CERTIFICATE OF REMEDIATION

Property: 901 Cortlandt Street, Lot 12, Block 229, Houston Heights Subdivision. The property includes a historic 1,260 square foot, one-story wood frame single-family residence situated on a 3,300 square foot (50' x 66') corner lot.

Proposal: Alteration – Without HAHC authorization, four windows have been removed and large sections of siding have been replaced by the previous owner. The current owner proposes to reverse the unauthorized window and siding alterations back to the original pattern/configuration. The property has been Red Tagged multiple times for Permitting Violations including COA/Historical issues.

HAHC Action: Denied – COR issued

NORTH SIDE ELEVATION

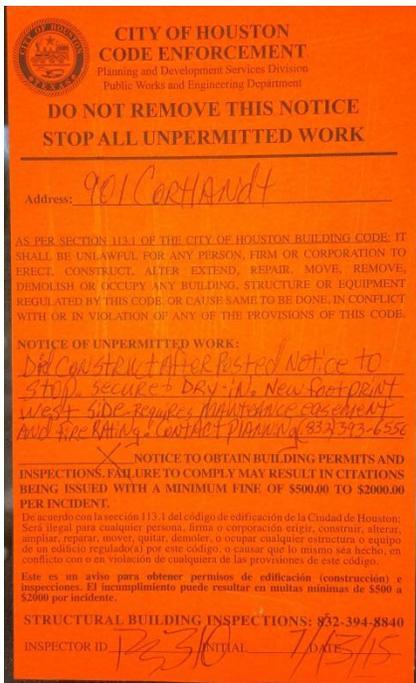
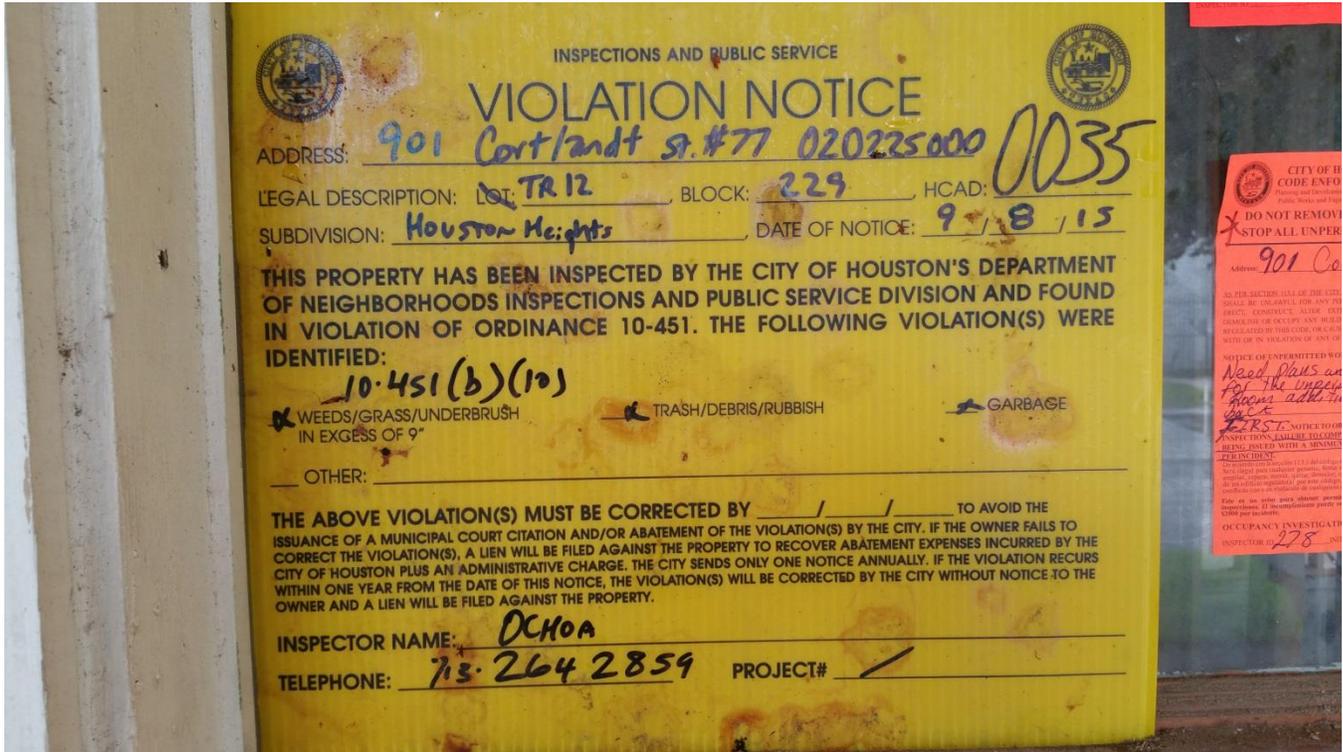
- Removed three windows on the south elevation
- Removed and reduced the size of an original window/opening on the north elevation
- Removed a non-original door on the north elevation
- Removed and replaced about half the original 117 wood siding with new 117 wood siding on the north and south elevations

On the south elevation (facing E. 9th St), the rear pair of 30" x 63" windows was removed and sided over. The single 24" x 48" window was also removed and sided over. The original openings will be reopened and salvaged wood windows matching the original 30" x 63" and 24" x 48" will be installed. On the north elevation, the 24" x 48" window was removed, the opening reduced in size, and a smaller window installed. The original opening will be reopened and salvaged wood window matching the original 24" x 48" will be installed. The non-original door and opening have been removed and will not be returned. See photos for more detail.

- Restore the original fenestration pattern using salvaged windows to match original
- Retain the new replaced 117 wood siding as currently installed
